Gleneagle Stormwater Treatment Facility

DATE: May 2, 2025

ADDENDUM NO. 1

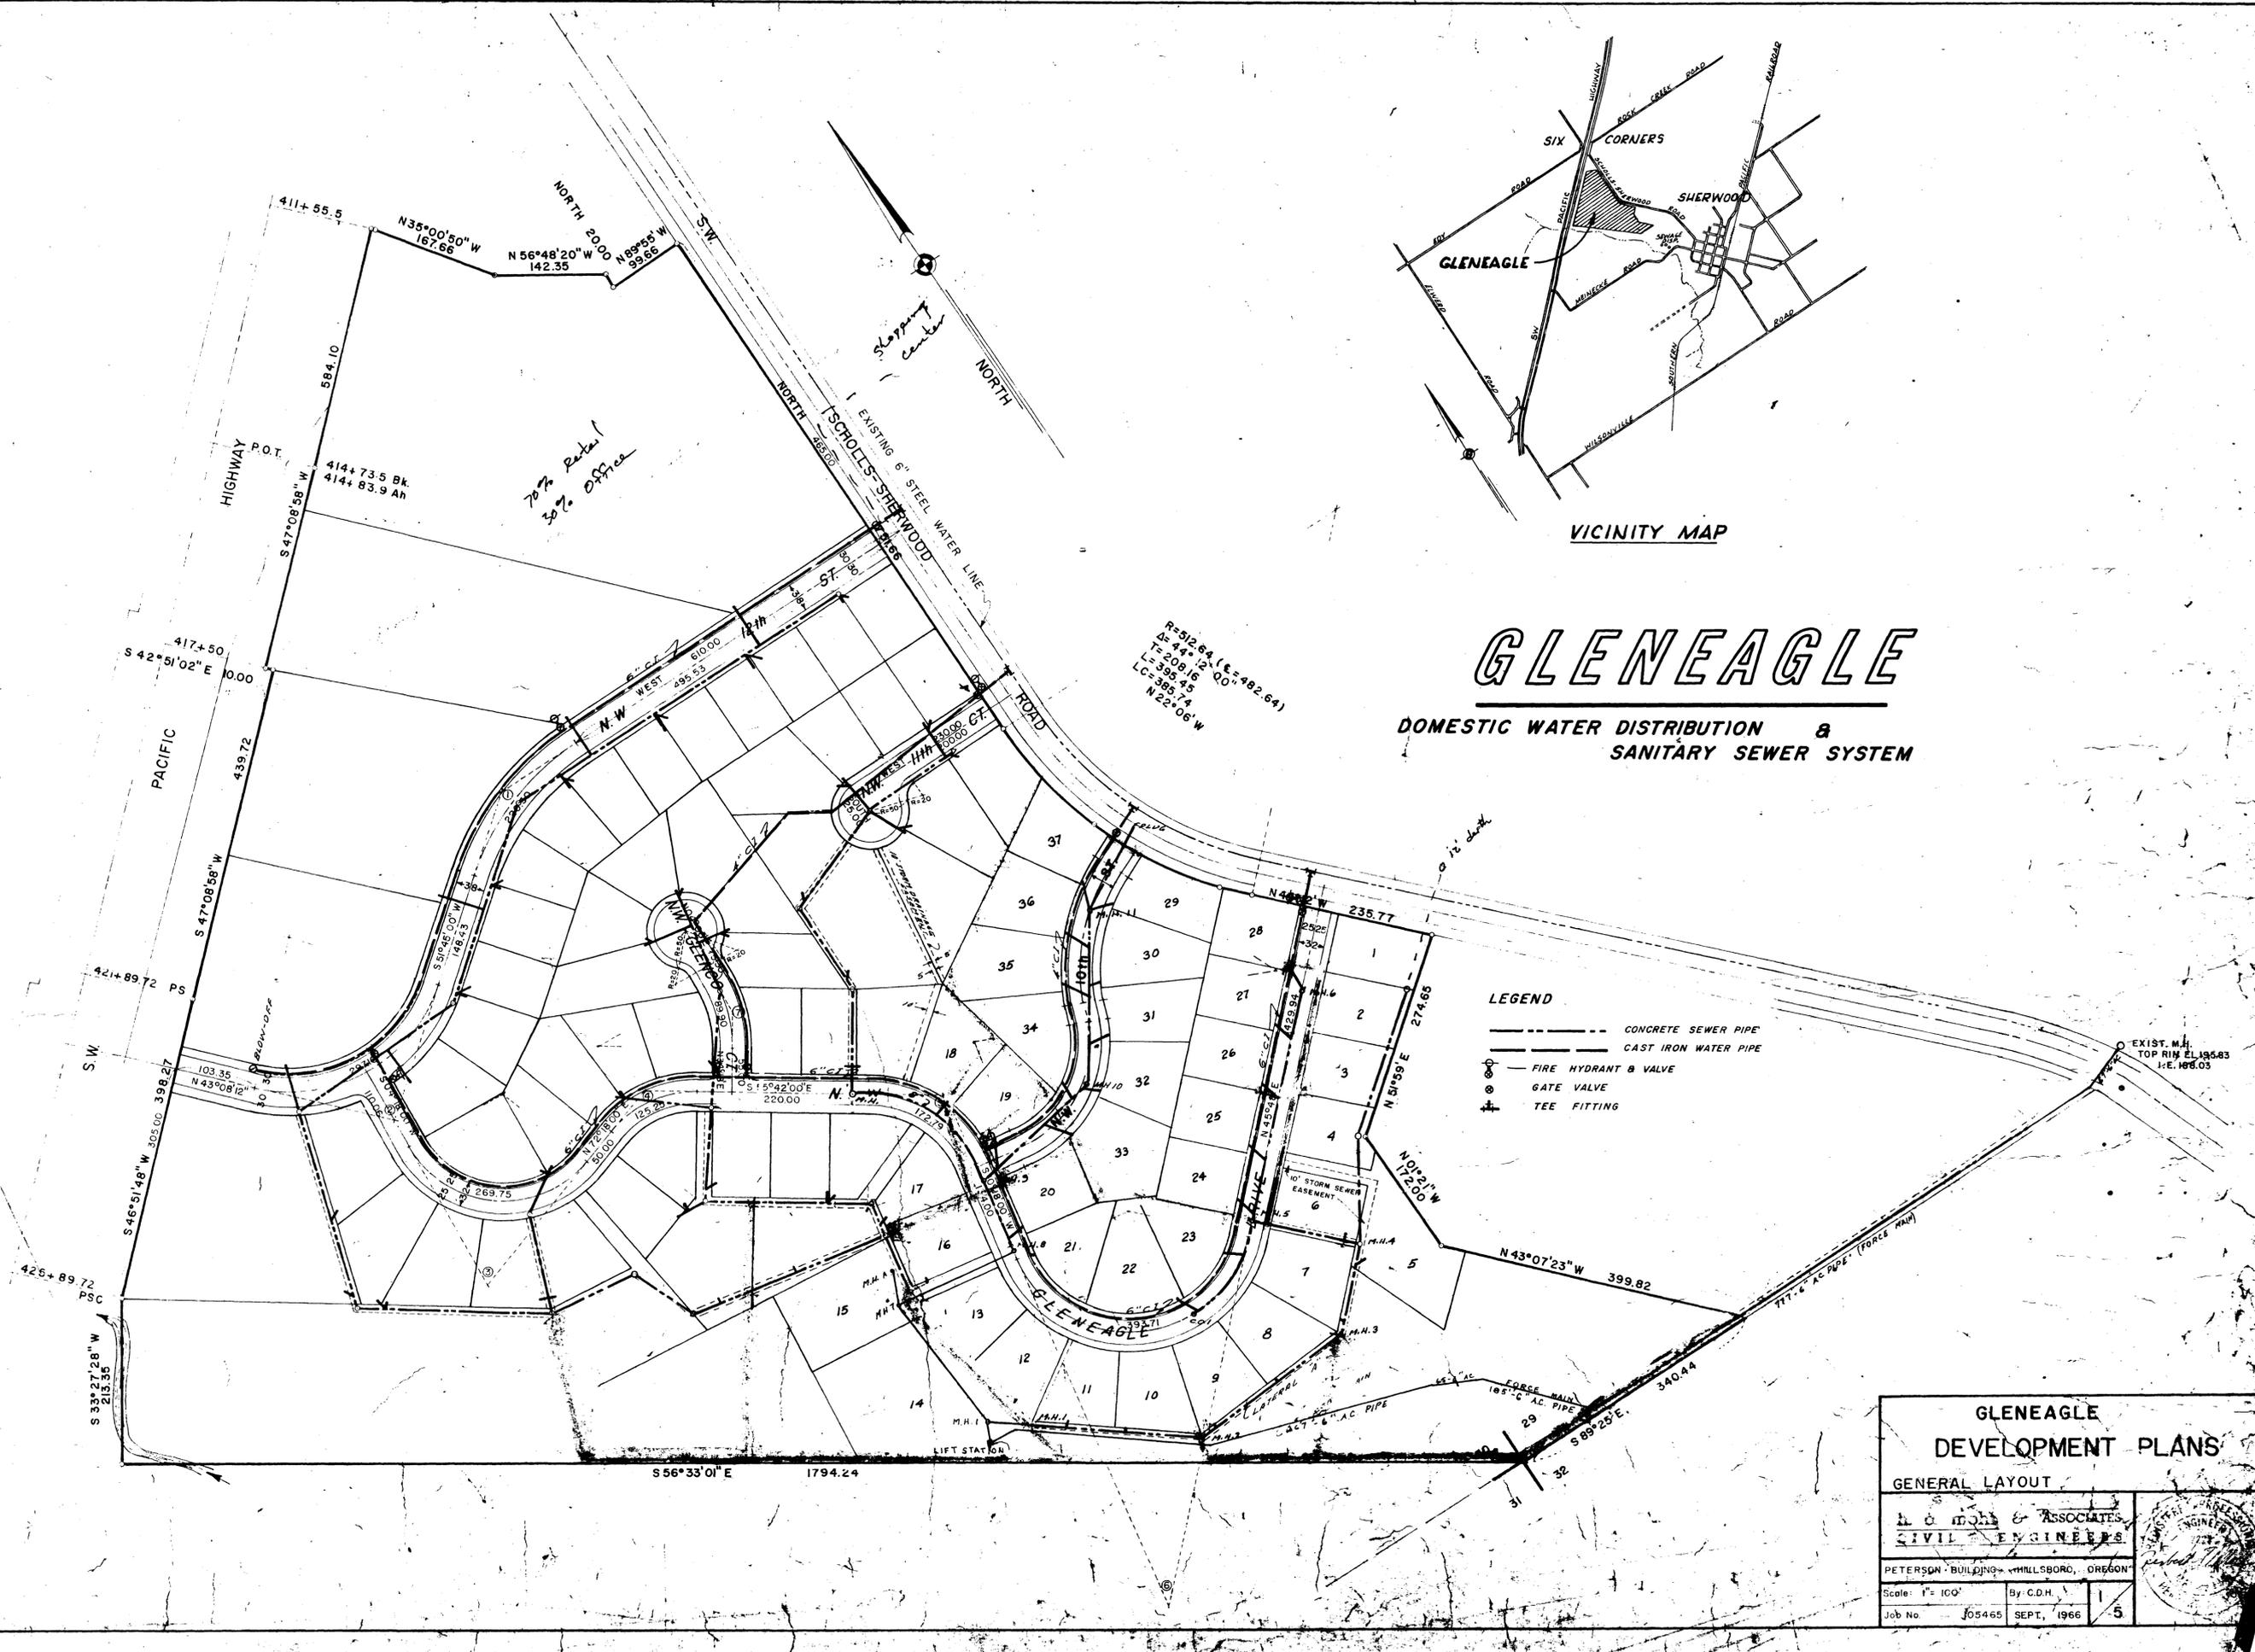
9. Is there any way to remove the liability from the contractor for the failing wood retaining wall that interfaces with the new block wall? That liability should be on the landowner, the city, or the engineer, but not the contractor and its wall design engineer. **It will be up to the contractor to make the connection between the block wall and the wood wall. Neither the city nor the engineer of record will be assuming the liability for the wall. I'm not sure that I'd classify the existing wood wall as "failing". It encroaches into the city property and therefore needs to be removed as shown to allow for the construction of the new access road with a new wall being installed to retain the earth.**
